Work Order ID **93999**

Item Name: Crosstube Turning Detail

<b>DART AEROSPACE LTD</b>		<b>Work Order:</b> 93999
<b>Description:</b> Crosstube Assembly (412 High Aft)		<b>Part Number:</b> D412-664-243
<b>Inspection Dwg:</b> D412-664-243 Rev: E		<b>Page 1 of 2</b>

DRAWING NO. D412-664-243	TITLE CROSSTUBE ASSEMBLY (412 HI AFT)	REV. E	DART AEROSPACE LTD ENGINEERING ORDER		D.E.O. NO. D412-664-243-E-1	SHEET NO. SHEET 1 OF 2	SCALE NTS
DRAWN	CHECKED	MFG. APPR.	APPROVED	DE APPR.			
DATE 11.03.31	DATE 11/03/31	DATE 11.03.31	DATE 11/03/31	DATE 11.03.31

DRAWING NO. D412-664-243	TITLE CROSSTUBE ASSEMBLY (412 HI AFT)	REV. E	DART AEROSPACE LTD ENGINEERING ORDER	D.E.O. NO. D412-664-243-E.1	SHEET NO. SHEET 2 OF 2	SCALE NTS
DRAWN	CHECKED	MFG. APPR.	APPROVED	DE APPR.		
DATE 11.03.31	DATE 11.03.31	DATE 11.03.31	DATE 11.03.31	DATE 11.03.31

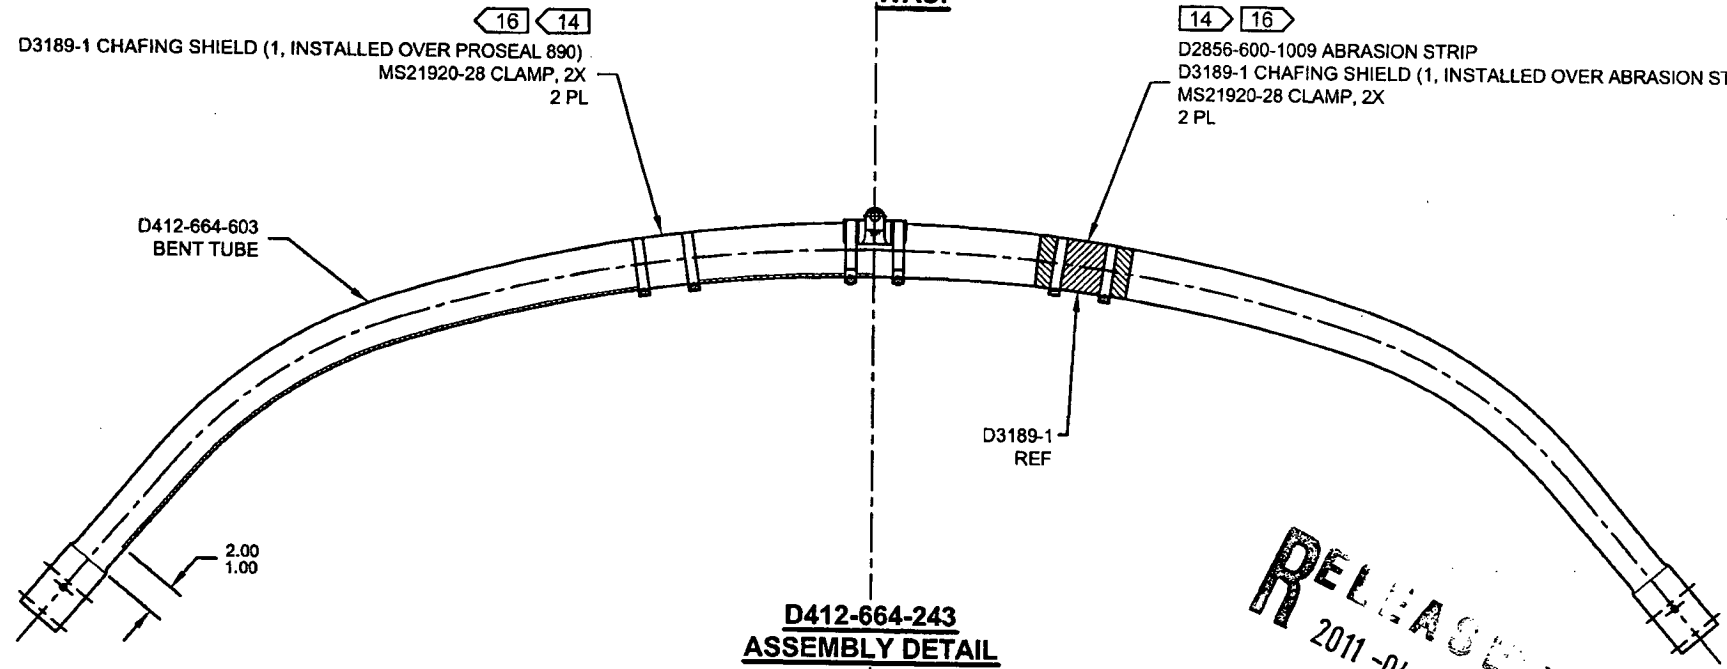
REMOVED ABRASION STRIP IN FAVOR OF A THIN LAYER OF PROSEAL 890.

REMOVED ABRASION STRIP IN FAVOR OF A THIN LAYER OF PROSEAL 890. UPDATE INSTALLATION OF CHAFING SHIELDS AND REDUCE TORQUE TO 40-50 IN-LBS. THIS ENGINEERING ORDER SUPERCEDES DEO D412-664-243-E-1.

D3189-1 CHAFING SHIELD (1, INSTALLED OVER PROSEAL 890)  
MS21920-28 CLAMP, 2X  
2 PL

D2856-600-1009 ABRASION STRIP  
D3189-1 CHAFING SHIELD (1, INSTALLED OVER ABRASION STRIP)  
MS21920-28 CLAMP, 2X  
2 PL

**D412-664-243  
ASSEMBLY DETAIL**

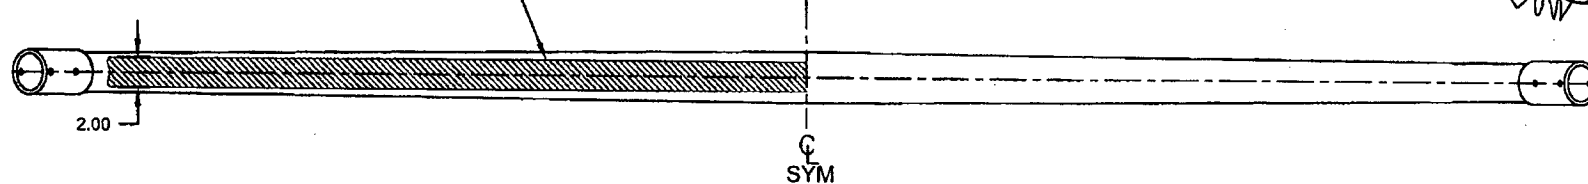
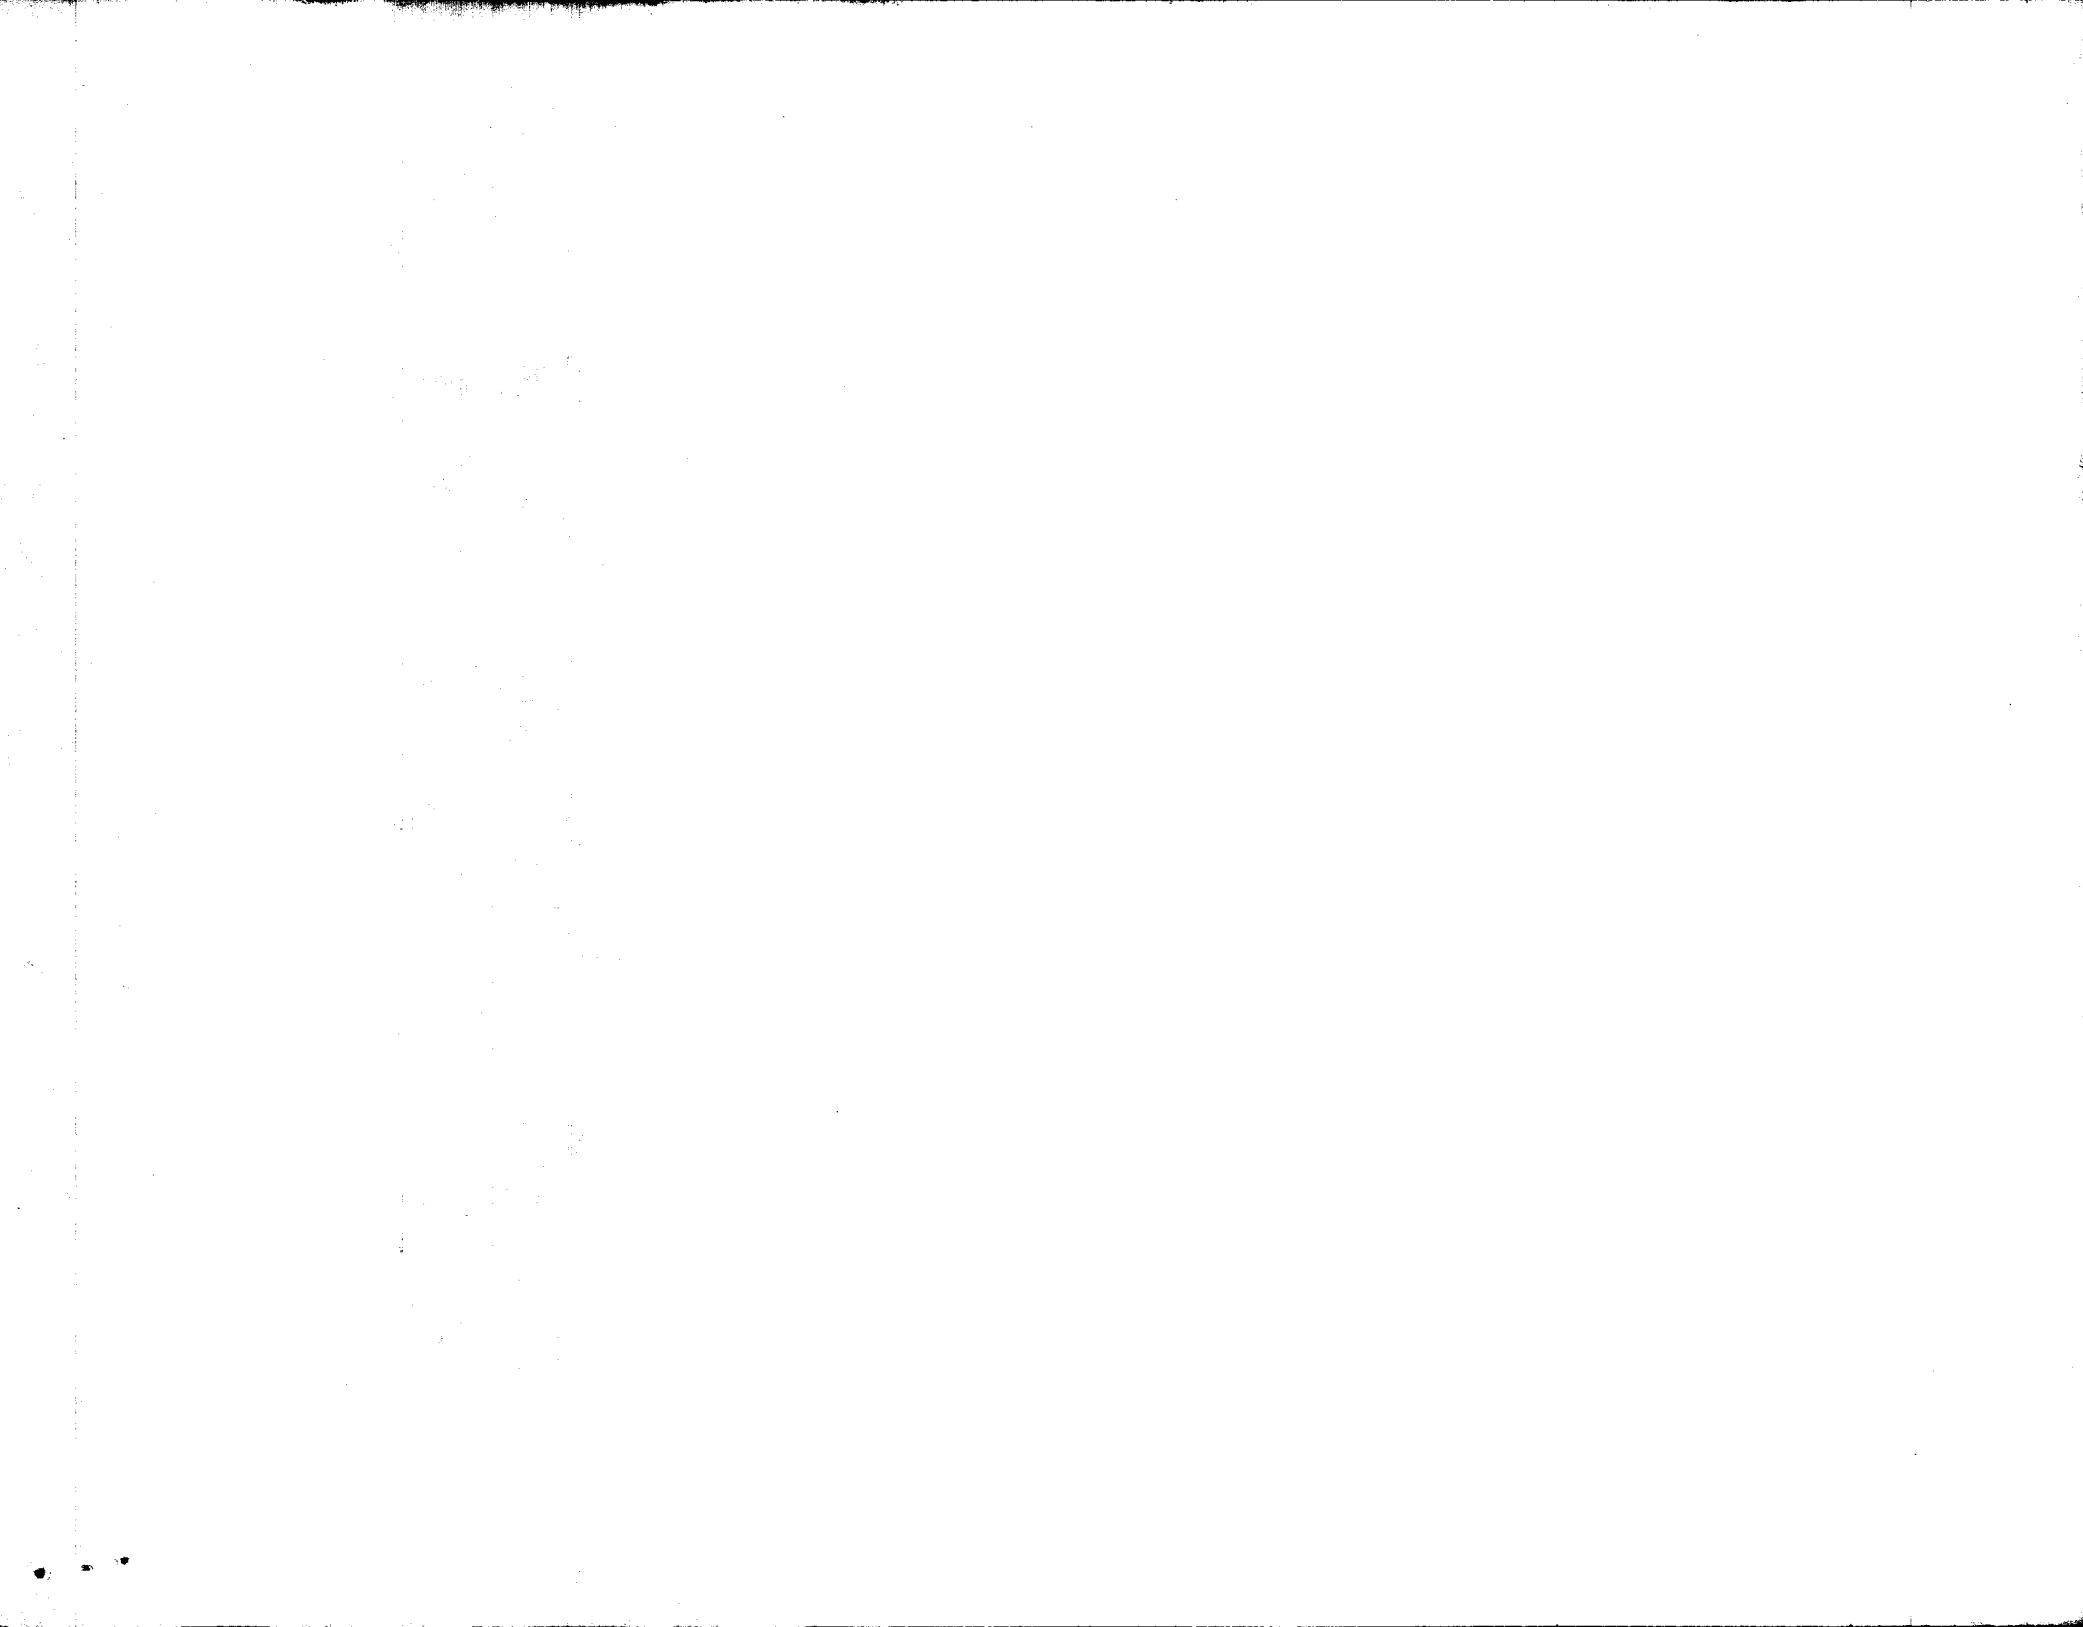
MASK AREA PRIOR TO PAINTING AND  
APPLY CLEAR COAT AFTER PAINTING

- 2) FINISH: CHEMICAL CONVERSION COAT PER DART QSI 005 4.1  
PRIME INSIDE AND OUTSIDE PER DART QSI 005 4.2  
MASK UNDERSIDE OF CROSSTUBE AS SHOWN (HATCHED AREA)  
PAINT OUTSIDE PER DART QSI 005 4.2  
AFTER PAINTING, APPLY CLEAR COAT ON HATCHED AREA
- 14) APPLY A THIN COAT OF PROSEAL 890 ON INSIDE CONCAVE SURFACE OF D3189-1 CHAFING SHIELD AND LET CURE PER MANUFACTURER'S INSTRUCTIONS. INSTALL PROSEALED D3189-1 CHAFING SHIELD ONTO CROSSTUBE BY APPLYING A THIN COAT OF PROSEAL 890 ONTO CROSSTUBE. BE SURE TO ELIMINATE ANY AIR GAPS.
- 16) TORQUE CLAMPS ON D2896-1 SUPPORT 80 TO 100 IN-LB. **TORQUE CLAMPS ON D3189-1 CHAFING SHIELD 40 TO 50 IN-LB.** ENSURE AT LEAST 1.5 THREADS SHOWING IN SAFETY AND THAT NUT HAS NOT BOTTOMED-OUT AFTER TORQUING.
